SUBJECT: SUMMARY OF CONFERENCE CALL WITH DONALD C. COOK NUCLEAR
PLANT UNIT 1 REGARDING THE FALL 2014 STEAM GENERATOR
INSPECTIONS (TAC NO. MF4714)

CONFERENCE CALL SUMMARY

REGARDING DONALD C. COOK NUCLEAR PLANT, UNIT 1

FALL 2014 STEAM GENERATOR INSPECTIONS

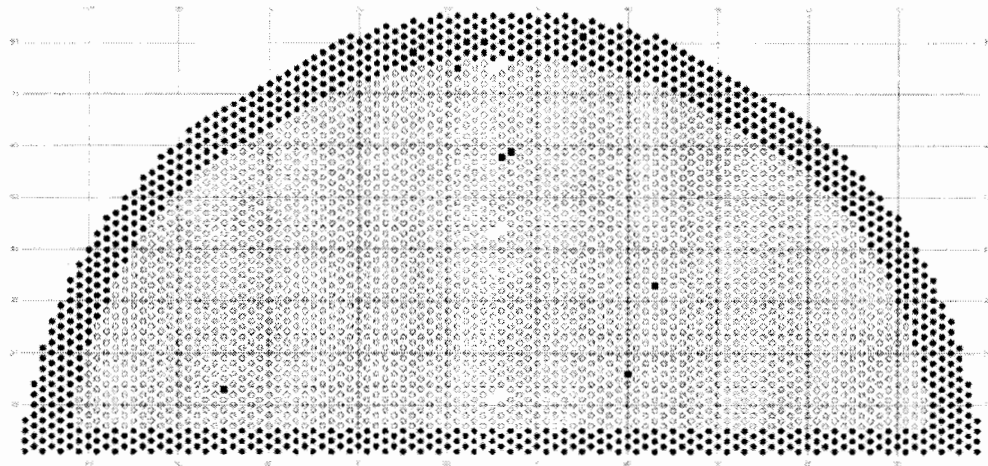
8. Discuss the following regarding loose parts:

- what inspections are performed to detect loose parts
- a description of any loose parts detected and their location within the SG (including the source or nature of the loose part, if known)
- if the loose parts were removed from the SG
- indications of tube damage associated with the loose parts

R8: Loose part inspections include:

- Visual inspections at the top of the hot and cold leg tubesheets
 - Divider lane
 - Bundle periphery
 - Historical loose part locations
- +Point probe examination is being performed on the hot and cold leg peripheral tubes (+/- 3") at the top of tubesheet. The typical examination pattern is shown below by the red tubes.
